Document AVC-832

Title: Comments on drafts H.22Z and H.323
TUB/TEL-03-A

This contribution presents some of our comments on the draft recommendations H.323 (revision #5) and H.22Z (revision #3).

4.2 Section 6. Call Signaling

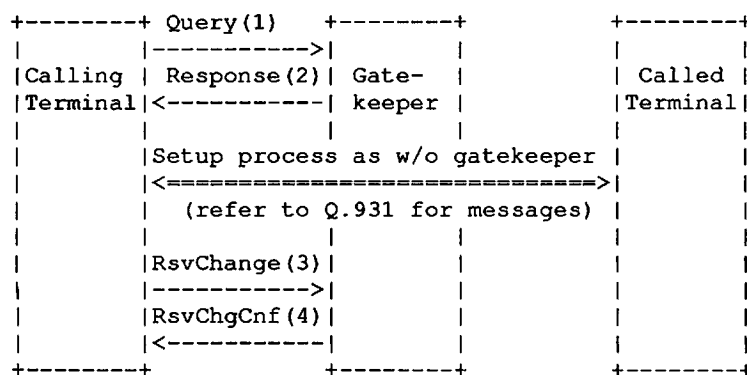
- a) H.323 suggests usage of an unreliable channel to avoid setup latencies and packet overhead. Even having multiple IP routers in a path between two end systems produces round trip times (on a campus ethernet/fddi) in the order of 5-10 ms (five routers on the path). Connection setup in established transport protocols (such as TCP) proceeds very quickly, so that the first data packet is expected to arrive at the target host in approx. 15 ms. We do not see the two additional packets as critical for the setup. The single severe problem we see in this context is the availability of a sufficiently large number of sockets at the gateway / gatekeeper. Maybe there is an easier solution than using a connectionless transport and defining a new reliable protocol.
- b) The first paragraph also refers to Q.931 PDUs being carried in H.22Z packets; this should be corrected (see comment to 5.2).
